Applicants request a Special Exception under Section 2.16.050 J (Carport over a Driveway) in an R-3/sc (Residential/special contract) zone.

SUBJECT:   CARPORT CASE FOR February 13, 2012 ZBA MEETING

I have reviewed the plans for ZBA case PZBA12-0002 located at 5853 Clydesdale Drive. The applicant is requesting a Special K Exception under Title 2.16.050 for a carport over the driveway.

PLOT

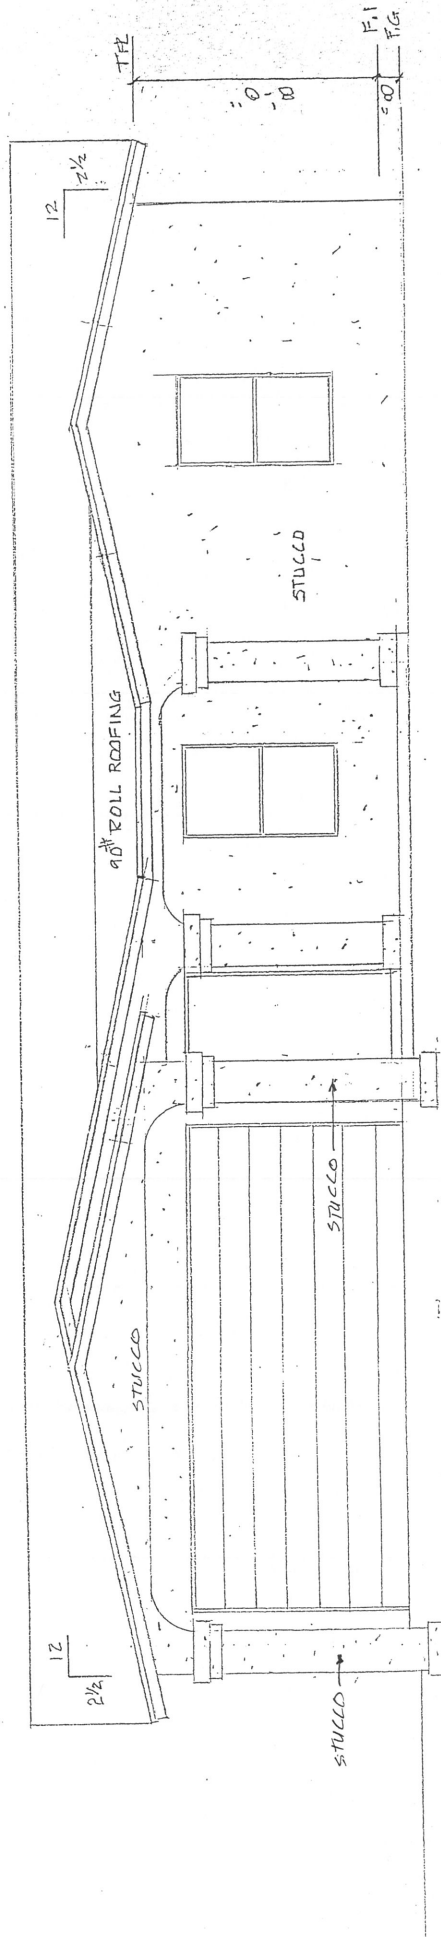
This would permit a 23' by 21' carport that is proposed to encroach into the front yard setback and to be located to within 1 foot of the front property line.

Requested front yard setback = 1'

Staff recommendation is for approval of the carport as it meets the requirements of the Special Exception J.

FRONT ELEVATION  
 $\frac{1}{4}"$

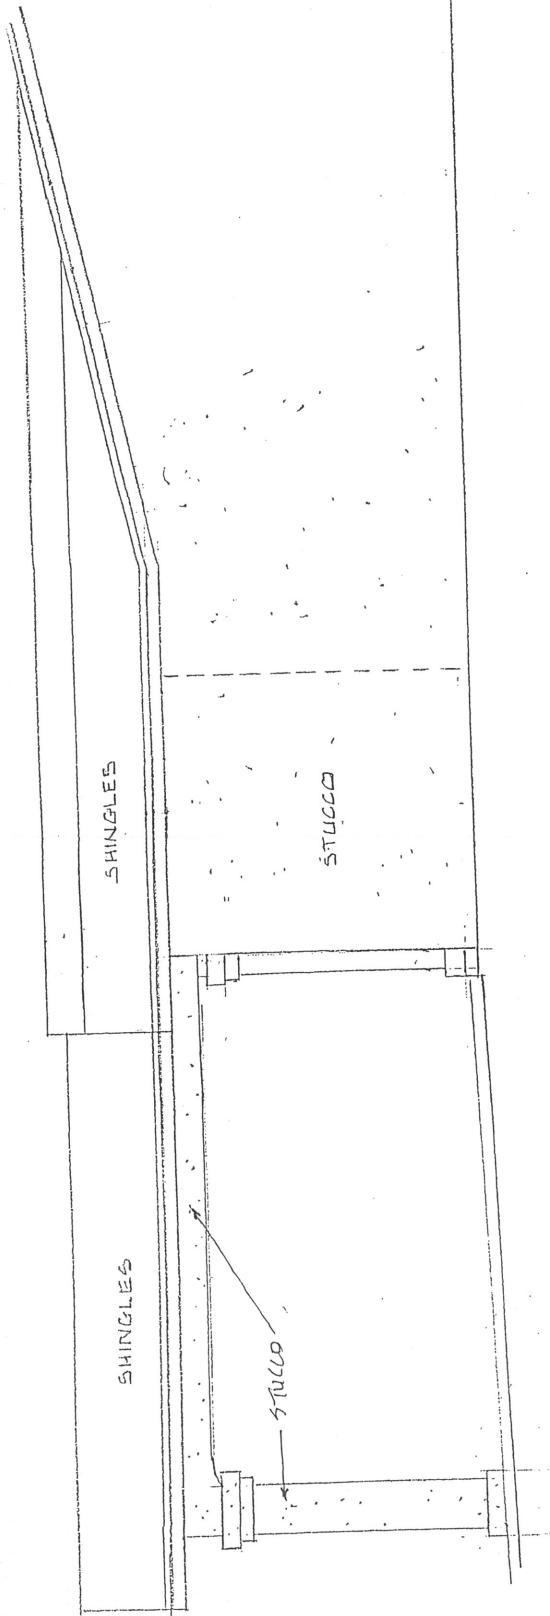
The applicants are requesting a carport which will encroach in the front yard setback. According to the submitted plans, the other additions at the front of the house do not encroach into the required front yard setback. The drawings indicate that the carport will not rise higher than the roof of the house and will match the house in design and materials. Building Permits & Inspections has reviewed and provided written approval of the carport structural plans.
